Re: Title 49 U.S.C. Chapter 301 Safety Recall; Big Bear American Made Choppers, Inc.

**PART 573 Defect and Noncompliance Report**

# SAFETY RECALL

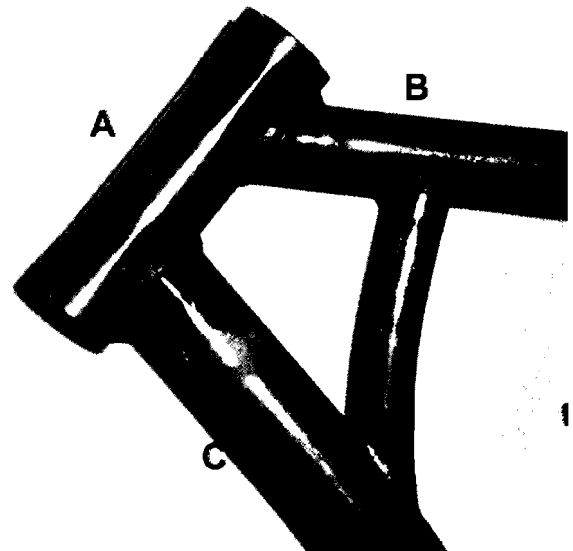
*The defect is a potential failure of a motorcycle frame at the point where frame tubes (B) and (C) connect to the Neck (A) as identified in illustration #1*

The primary cause is insufficient penetration of the weld joint where tubes (B and C connect to the Neck A) as identified in illustration #1

A secondary concern is, failure to maintain frame and engine bolts to the correct torque can cause excessive vibration in the frame which can contribute to advancement of the weld failure in the identified areas

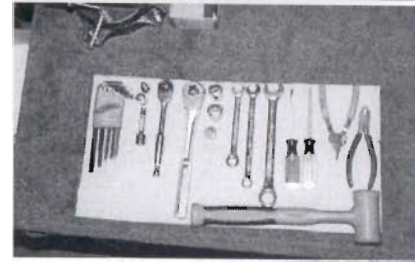
7. Visually inspect and note any obvious cracks around the neck, and top motor mount that is welded to the backbone

View showing upper joint ready for root weld pass

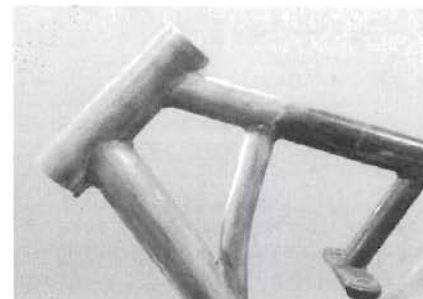
Continue with welding the second pass with a 3/32" ER70 rod. Inspect the second pass as above. Perform a third pass weld if required using .062" ER70 rod

Poster board template trimmed to fit in the frame opening.

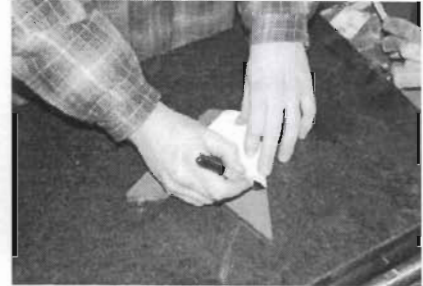
Create a poster board template that fits inside the opening inside the frame behind the neck

The template should represent the opening along the centerline of the tubes.

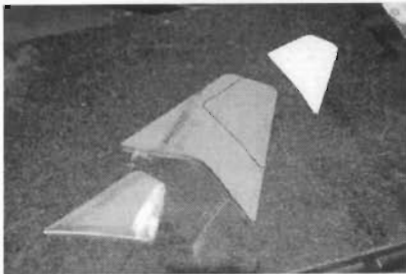
### EACH GUSSET MUST BE CUSTOM FIT TO WITHIN 1/32" (0.032") OF THE OPENING

Cut and grind the 1/4" plate so that it fits inside the frame opening. There should be no more than 1/32" gap all the way around the plate and the opening.

Example of a trimmed plate ready to be welded into frame opening.

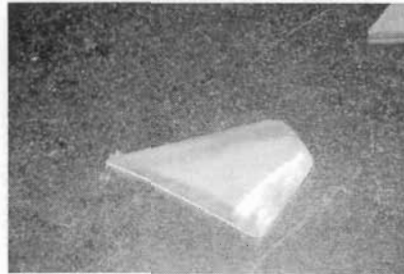
Proceed to tack weld the plate in place on both sides.

Completely weld the plate 100% of the perimeter on both sides.
